Document DCO 7.13 / MCO 7.13

# Applicants' Response to Deadline 2 and 3 Submissions

The East Midlands Gateway Phase 2  
and Highway Order 202X and The East Midlands Gateway  
Rail Freight and Highway (Amendment) Order 202X

Drawing Title  
**ACTIVE TRAVEL LINK INTERFACE WITH EMA AT END OF RUNWAY**

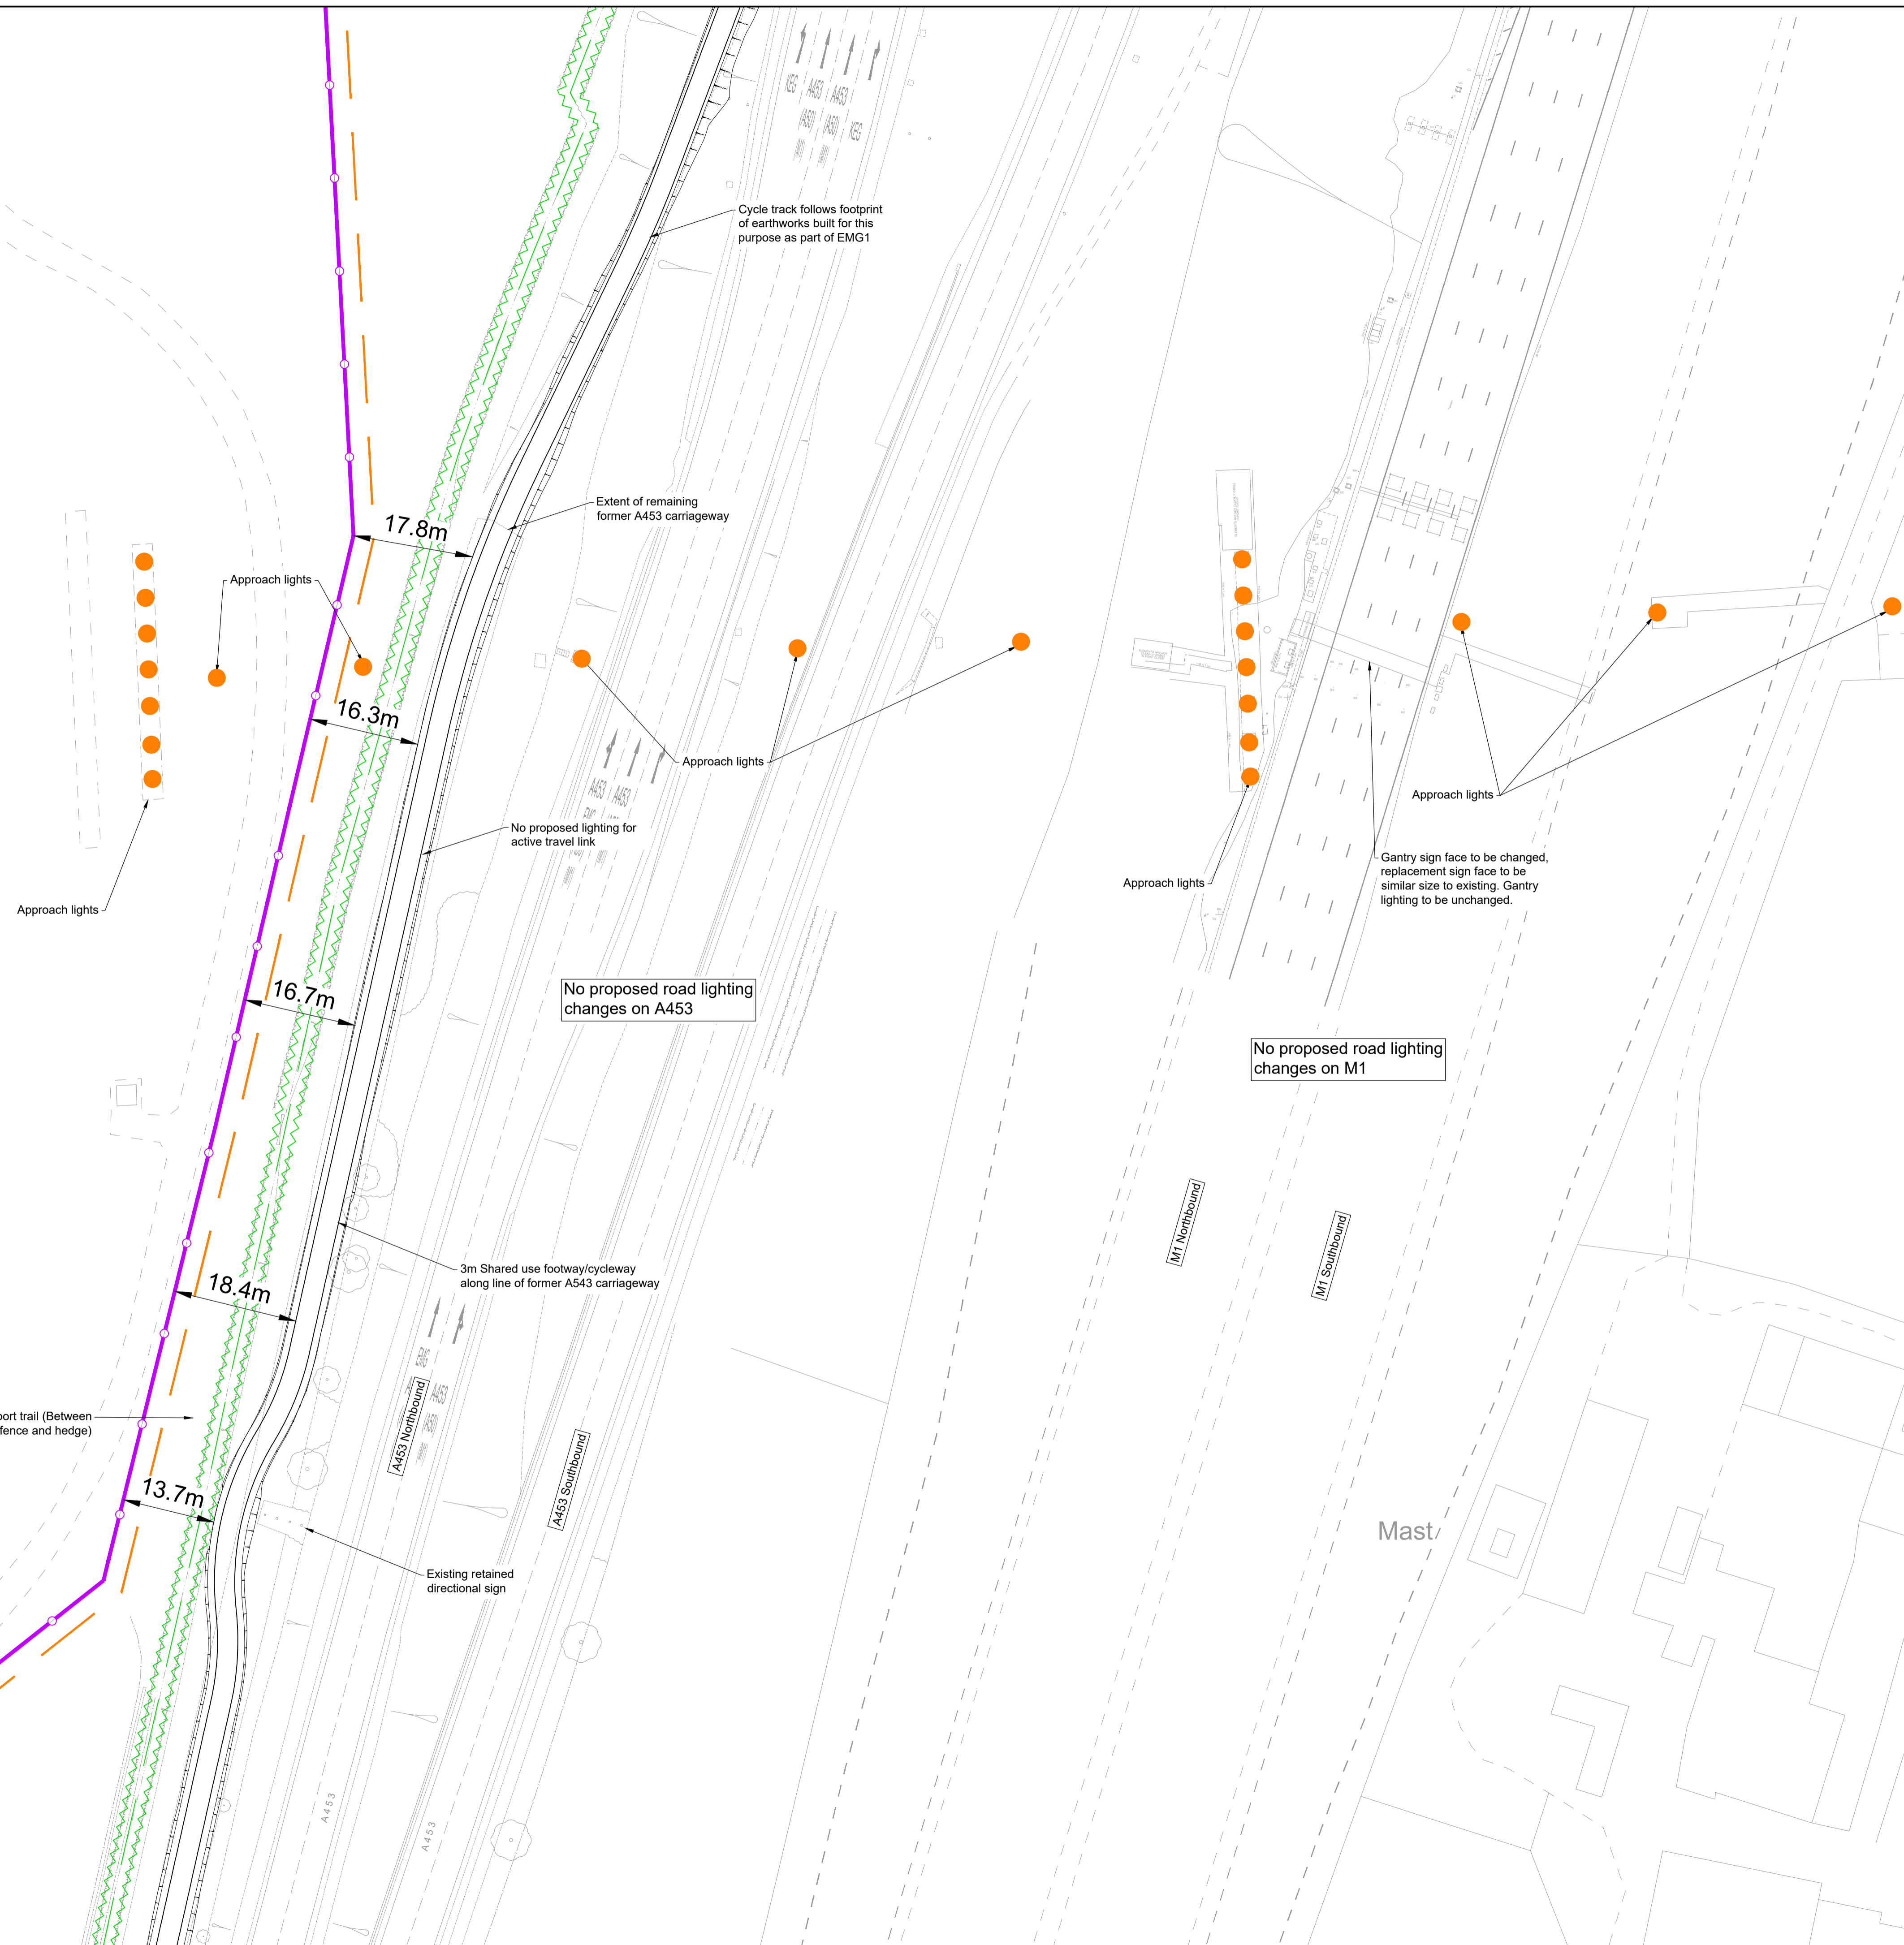
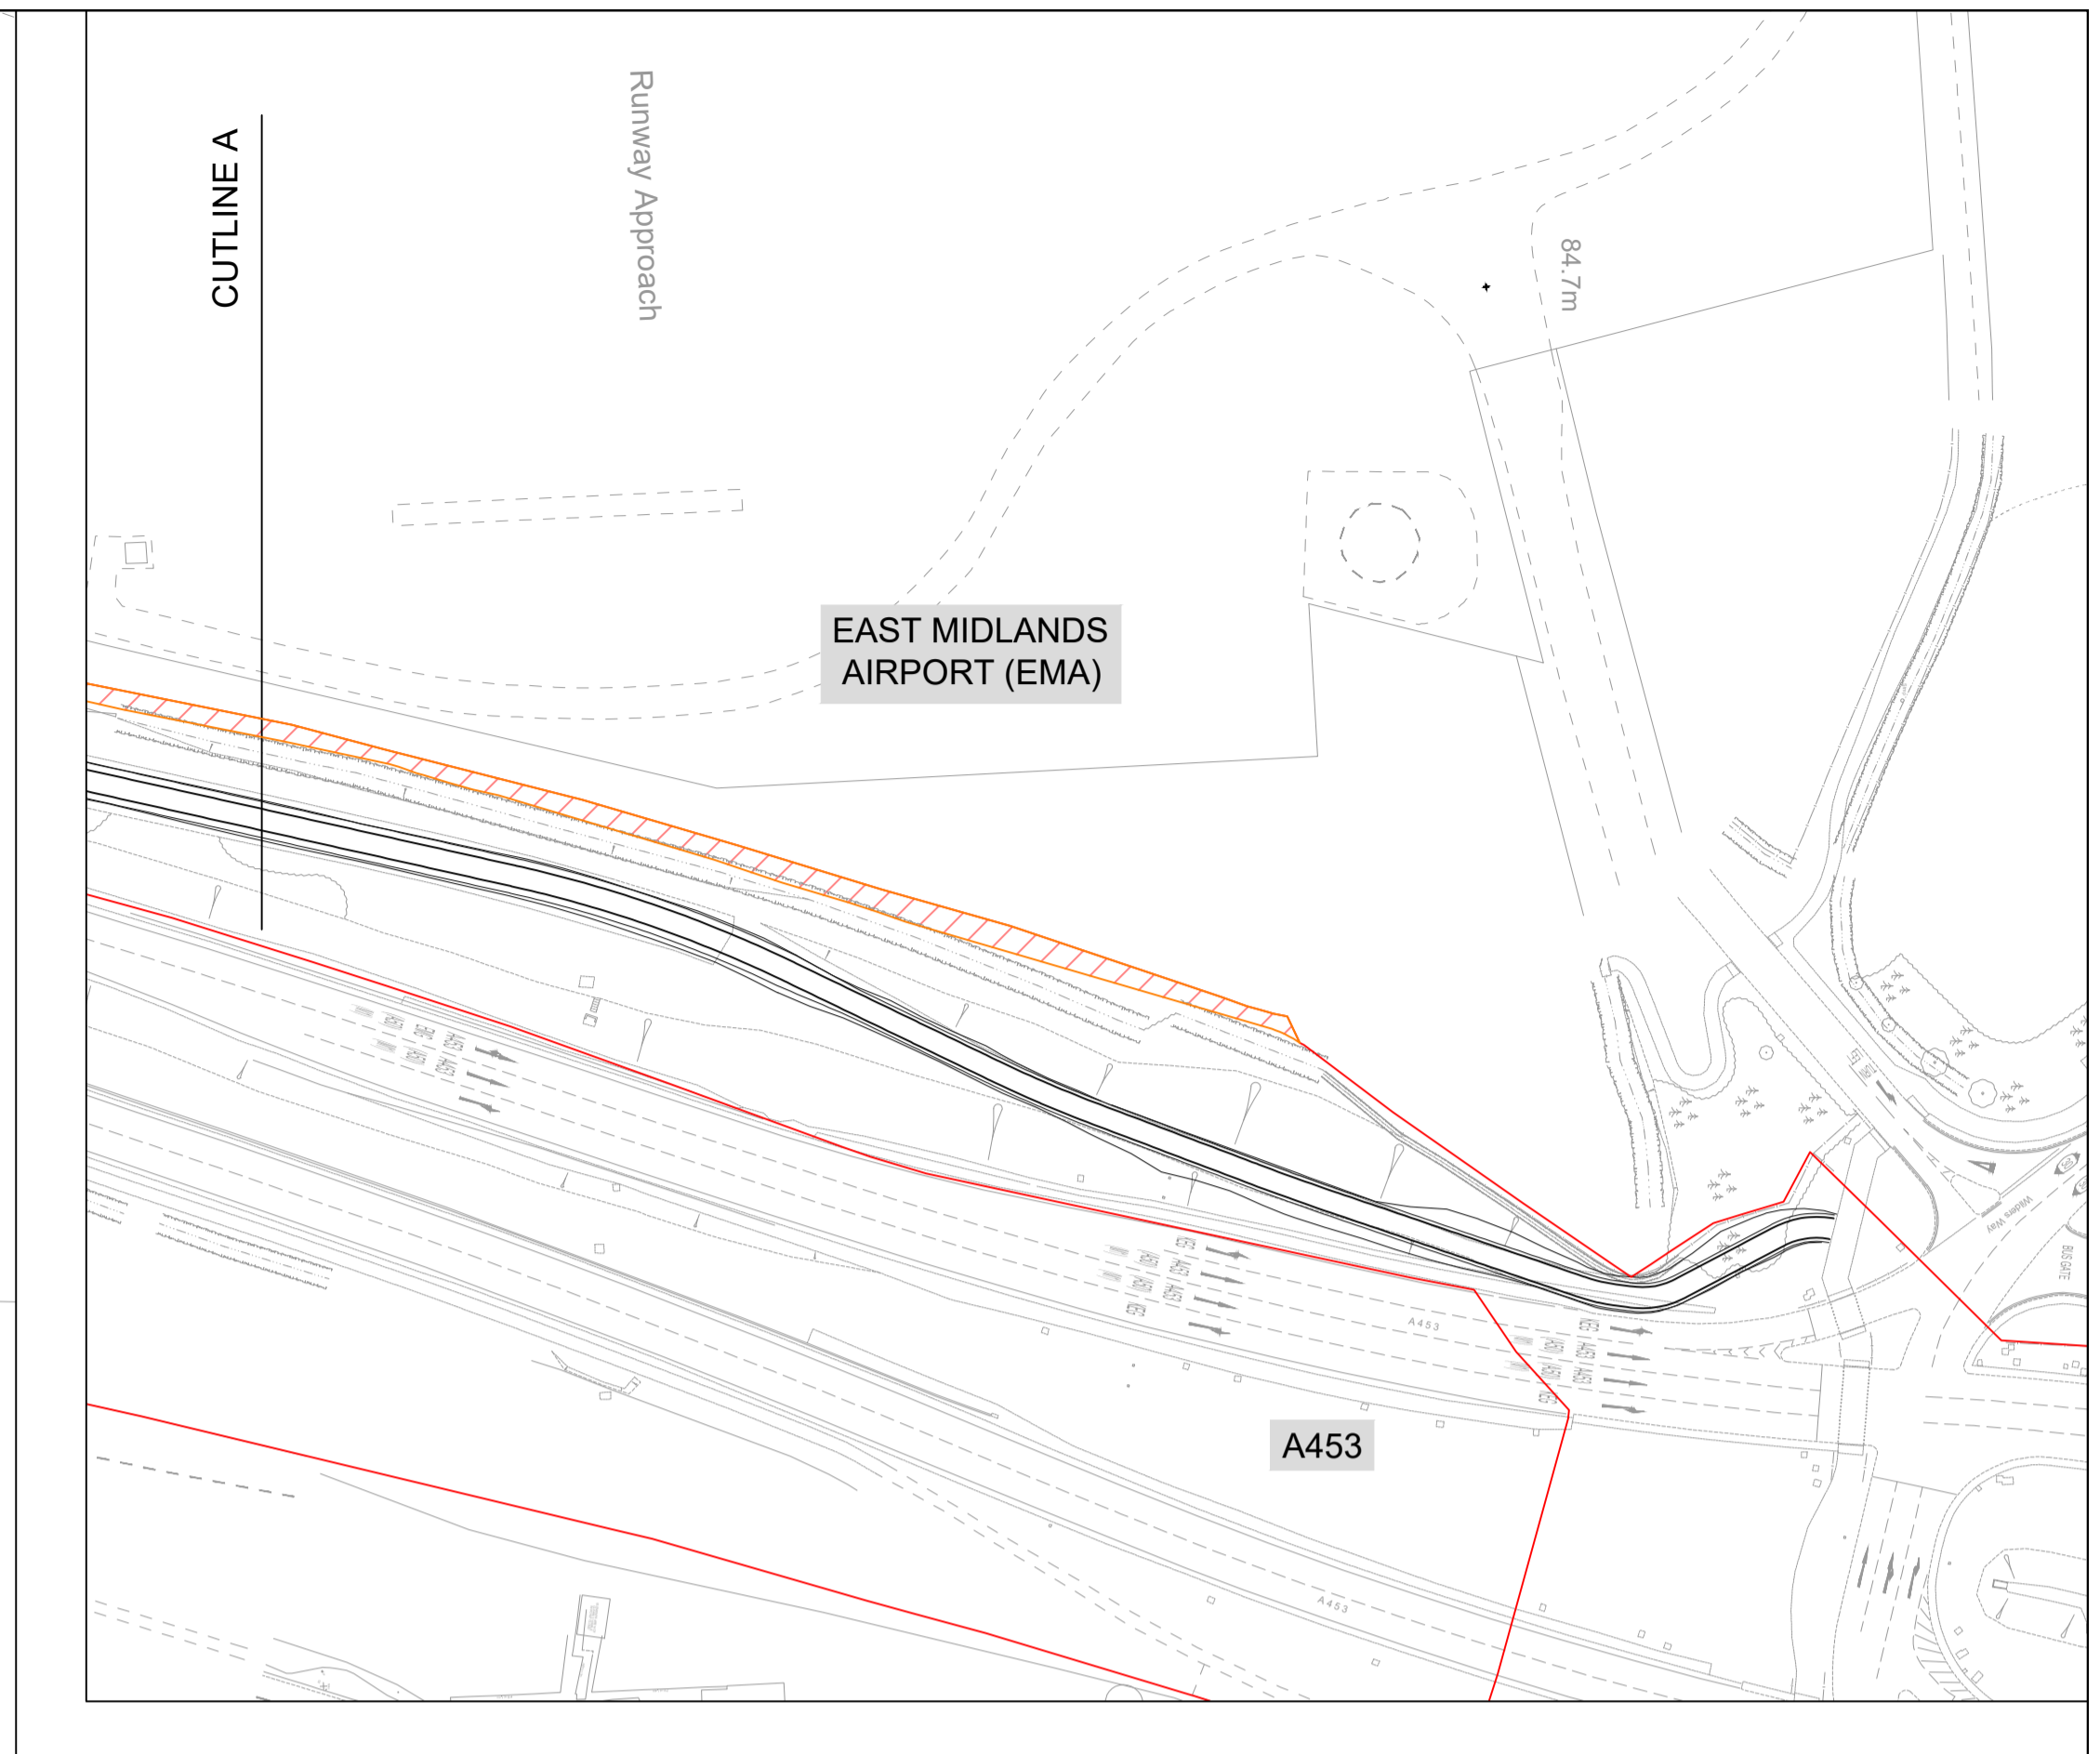
**DRAWING SHOWING ACTIVE TRAVEL LINK INTERFACE WITH EMA AT END OF  
RUNWAY / PLAN SHOWING REVISED ACTIVE TRAVEL LINK PLOT 2-6 CPO  
REQUIREMENTS**
